RELEASE: FINAL	Title : SL-6194/97-TX Schematic	
TOLERANCE: .XX: $\pm$ TOL-XX .XXX: $\pm$ TOL-XXX HOLE DIA: $\pm$ TOL-DIA ANGLE: $\pm$ TOL-ANG		
MATERIAL:		
FINISH:		
DRAWN: 31 May, 96		PART NO: <b>WILSON</b>
SCALE: PROJECTION: PROJN		REV: B
SHEET: 1

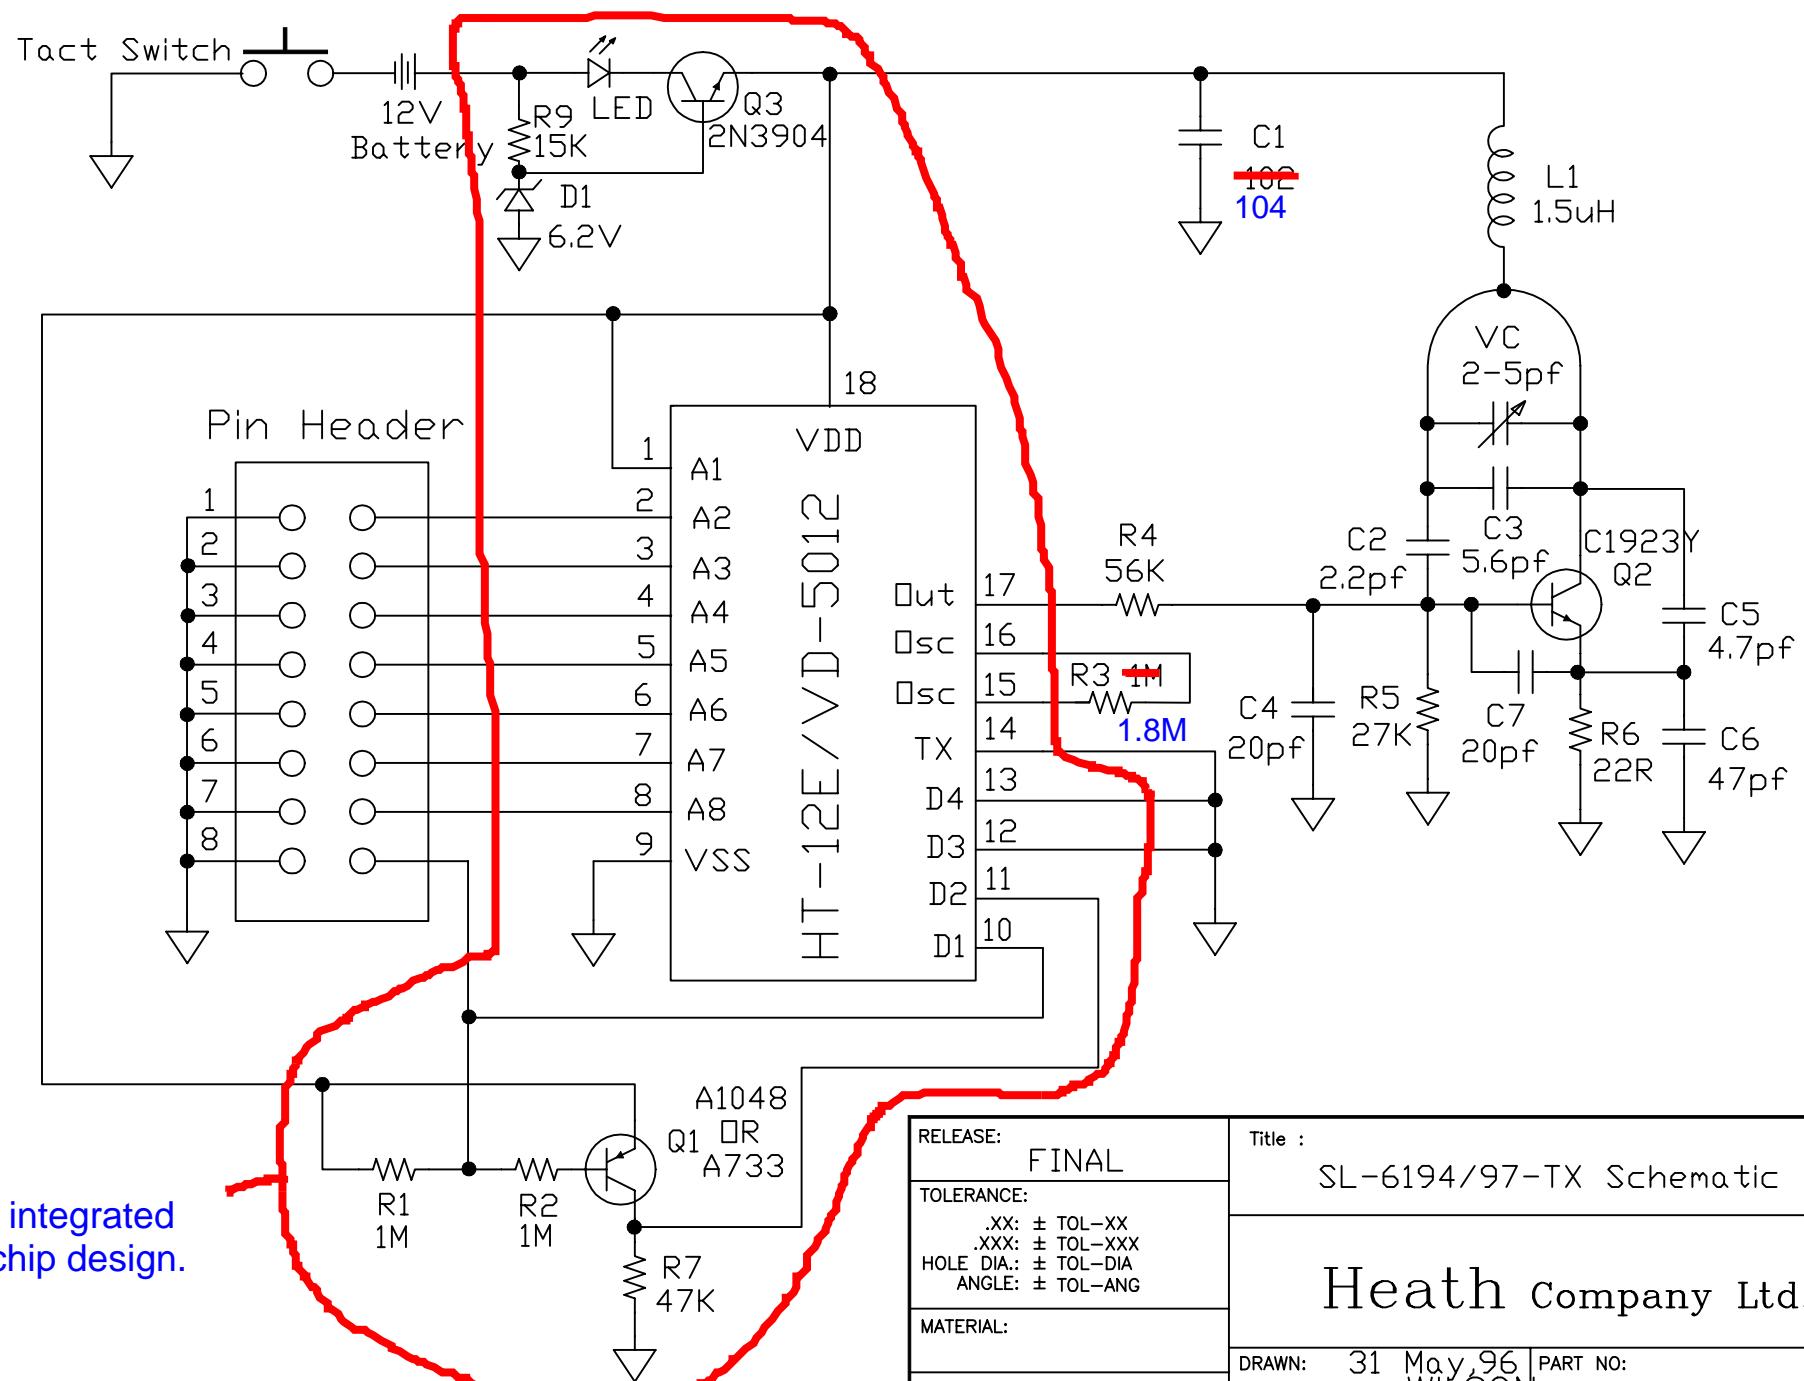
Rev:B The value of C4,C7,R4 and R5 are changed, were 12pf,4.7pf,8.2K and 1.8K respectively. 3194 & C1674 are deleted. Wilson 02/21/97  
 Rev:A Only use Tact SW., LED is moved, Del R8, R9 and D1 are changed, was 8.2K and 6.8V. Wilson 11 Dec,96
